Solicitation Addendum

Addendum No.: 2
Solicitation No.: 26-R089352DJ
Solicitation Title: Bishop Point Living Shoreline
Addendum Date: March 6, 2026
Procurement Contact: Dave Janney

TYPE C - DIMENSIONAL, REINFORCING, AND STEEL GRATE DETAILS

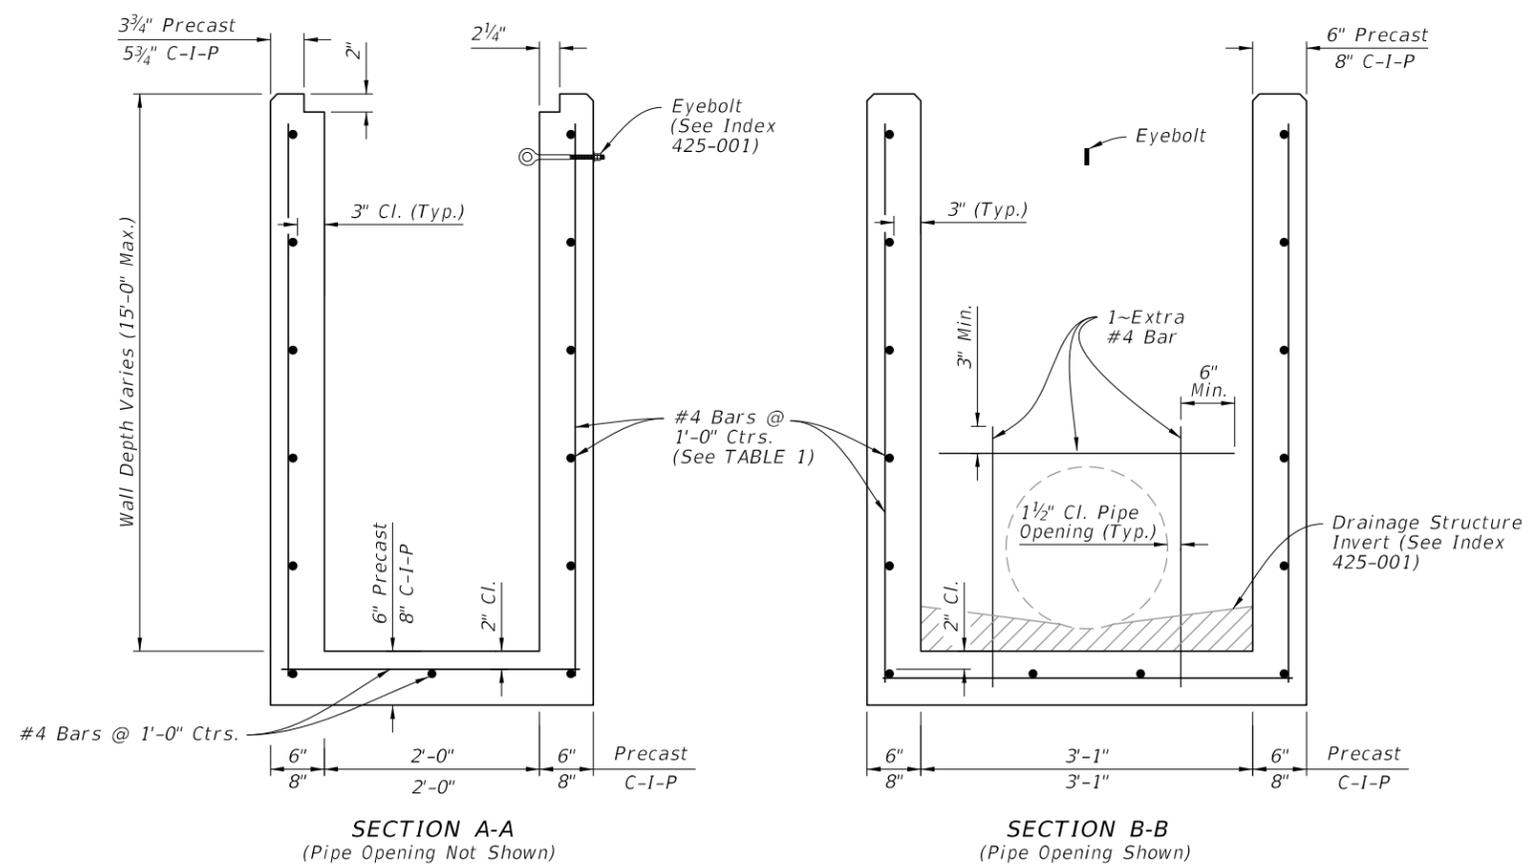
Q1. Any information detailing what the Type C Bubble Up Structure is?

R1. The structure shall be an FDOT Type C Ditch Bottom Inlet installed within the bioswale to allow for sheet flow and infiltration of the stormwater runoff from the surrounding drainage area. The Contractor shall reference FDOT Index 425-052, attached for reference.
